Southampton to London Pipeline Project

Site Specific Plan - Southwood Country Park
(tracked change)

Application Document: 8.60

Revision No. 2.0

Illustration 3.42: Aerial photography of TC014 in Southwood Country Park SANG

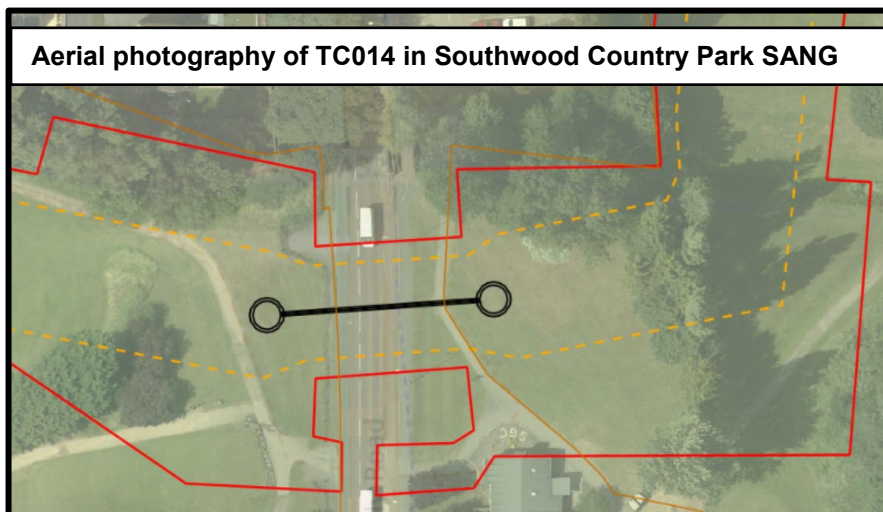
- 3.5.1 The works for this trenchless crossing will follow the methodology as outlined in the CoCP and will be tailored to the conditions of the park to reduce the amount of vegetation and tree clearance required. Details on how this will be applied at this location are summarised below.
- 3.4.23.5.2 The trenchless crossing of the A327 Ively Road will use the auger bore technique over approximately 32m.
- 3.5.3 There will be some vegetation clearance undertaken.
- 3.4.23.5.4 The launch pit will be located on the west side of the A327 Ively Road.
- 3.4.33.5.5 The reception pit will be located on the east side of the A327 Ively Road.

~~3.5.6~~ The pit areas will be topsoil stripped and neatly stored to one side of the pit area, which will provide additional noise and visual screening of the pit area from users of the country park. The pit area will then be covered with a permeable surface or protection matting.

~~3.4.5.3.5.7~~ No significant noise impacts have been identified in relation to this auger bore.

~~3.5.8~~ The pit area will be fenced with a 2m high perimeter fence that is bolted together for security and placed on rubber weighted feet for stability. The public facing façade of the fencing will be in accordance with RBC's design/requirements and will include project information and safety notices.

Illustration 3.23: Outline proposal for Cove Brook Dam crossing

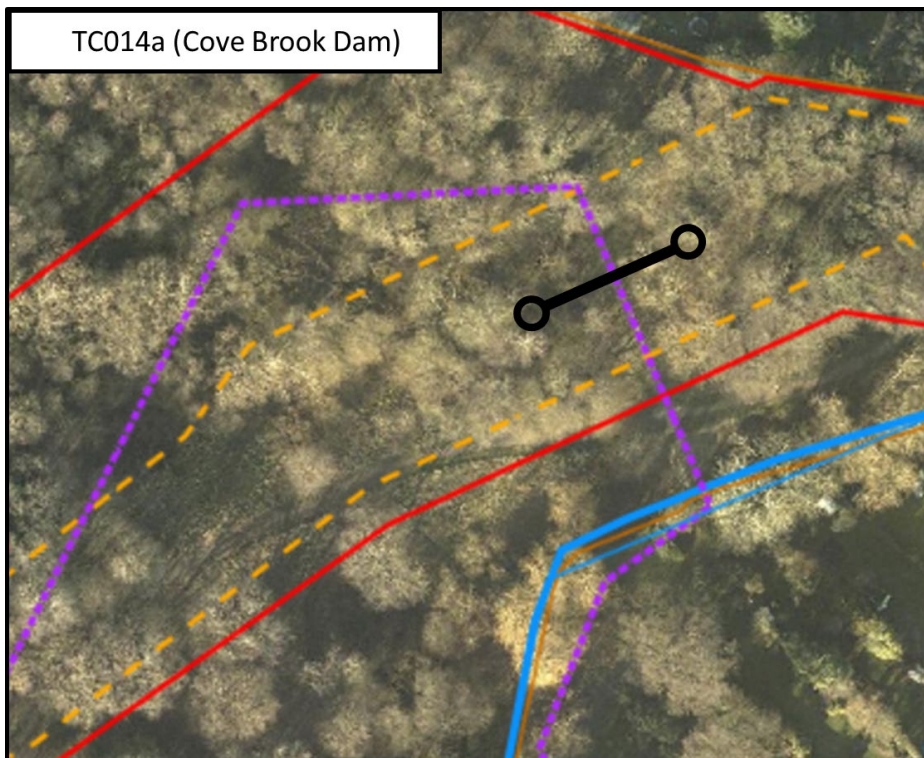
~~3.5.13.6.2~~ An auger bore technique will be used to cross the Flood Storage Area embankment. This crossing will be ~~area~~ about 25m long. Launch and reception pits will be constructed either side of the existing dam structure. The launch pit is to be located to the west of the Flood Storage Area and will be serviced from this direction.

~~3.5.23.6.3~~ The auger bore will commence once the launch and reception pits are complete. The pipe will be pushed from west to east (Southwood Country Park SANG to Cove Road) into the reception pit. The excavation will remain open for as short a period as possible but will only be concluded once the Open Cut pipe installation has been tied into the auger bore section of pipe.

- 3.6.4 The pit areas will be topsoil stripped and neatly stored to one side of the pit area, which will provide additional noise and visual screening of the pit area from users of the country park. The pit area will then be covered with a permeable surface or protection matting.
- 3.6.5 No significant noise impacts have been identified in relation to this auger bore.
- 3.6.6 The pit area will be fenced with a 2m high perimeter fence that is bolted together for security and placed on rubber weighted feet for stability. The public facing façade of the fencing will be in accordance with RBC's design/requirements and will include project information and safety notices.
- 3.6.7 These works can only be scheduled to be undertaken to take advantage of long-term forecasts making use of dry weather conditions.
